**Testimony of LANDMARK WEST!
Certificate of Appropriateness Committee
Before the Landmarks Preservation Commission
55 Central Park West
December 9, 2008**

The Certificate of Appropriateness Committee wishes to comment on the application to construct rooftop additions at 55 Central Park West, an Art Deco-style apartment building designed by Schwartz & Gross and built in 1930.

55 Central Park West
Construct rooftop additions

2 VIEW A FROM 65TH STREET
PROPOSED 19TH FLOOR EXTENSION, BRICK TO MATCH EXISTING

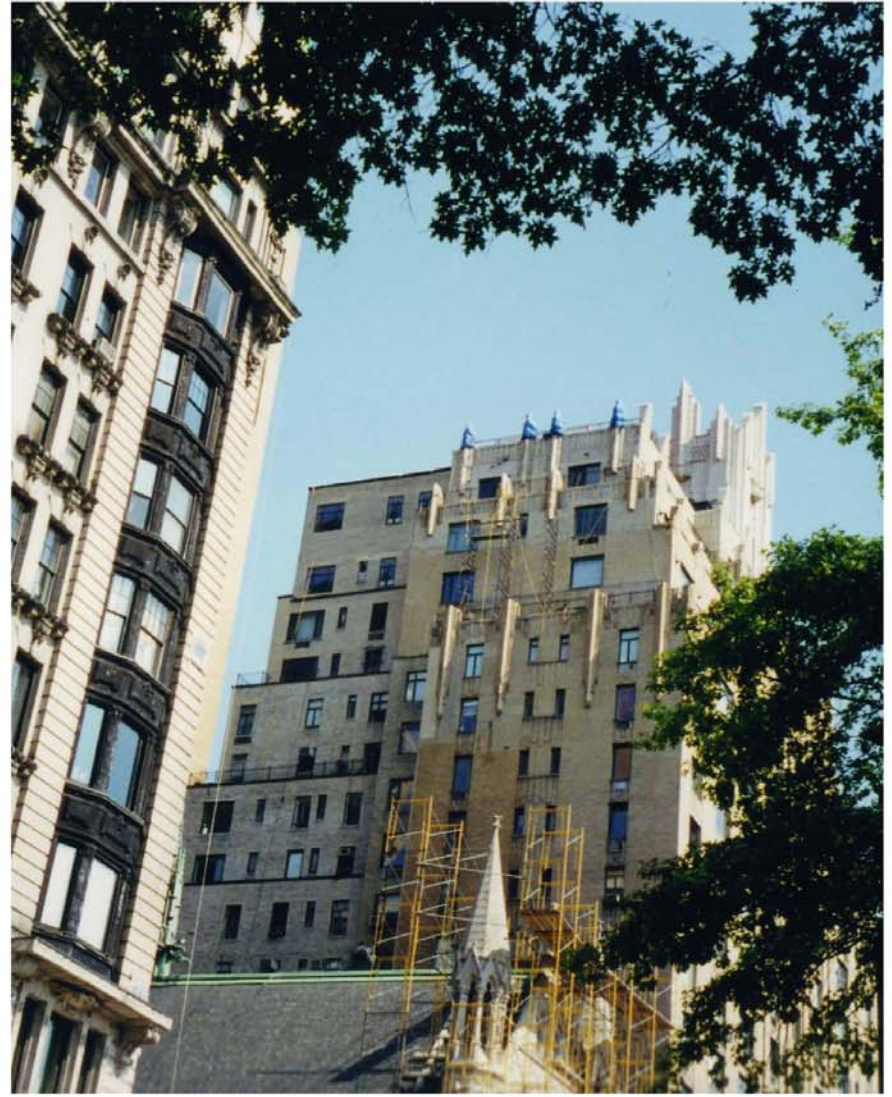
55 Central Park West is neighbored to the south by the diminutive Holy Trinity Church, leaving the south façade entirely exposed from the 9th floor up. The proposed addition at the 19th story would be entirely visible from West 65th Street and portions of both West 66th Street and Central Park West. This is contrary to Rule 2-19(e)(2)(iii), which dictates that rooftop additions be invisible from the public thoroughfare, and is, thus, inappropriate. Building out the 19th story setback would clearly interrupt the delicate massing that is so important to the building's character.

Precedence becomes an important issue here: If the Commission approves the infill of this setback, what is to stop the residents of the 11th, 13th, 15th, or 17th floors, where other setbacks occur, from proposing the same thing? Or residents of the Art Deco-style Century or Majestic apartments, for that matter? Little by little, setback by setback, the stepped quality of 55 Central Park West and other apartments could disappear. We urge the Commission to deny this first of the two rooftop additions proposed on this important principle.

Our Committee was also disappointed by the lack of information made available about materials. The color of the brick, the configuration of the windows, and the color of the window framing are not inconsequential. Their qualities must be carefully reviewed for appropriateness alongside the original building fabric. Though the proposed windows are said to conform to the windows master plan for 55 Central Park West, this plan was approved almost two decades ago in 1991 and amended just two years after that, in 1993. What version of Hopes windows are currently approved for this building? If the windows proposed today are indeed in line with the master plan, it is apparent to our Committee that a re-evaluation of the master plan is in order.
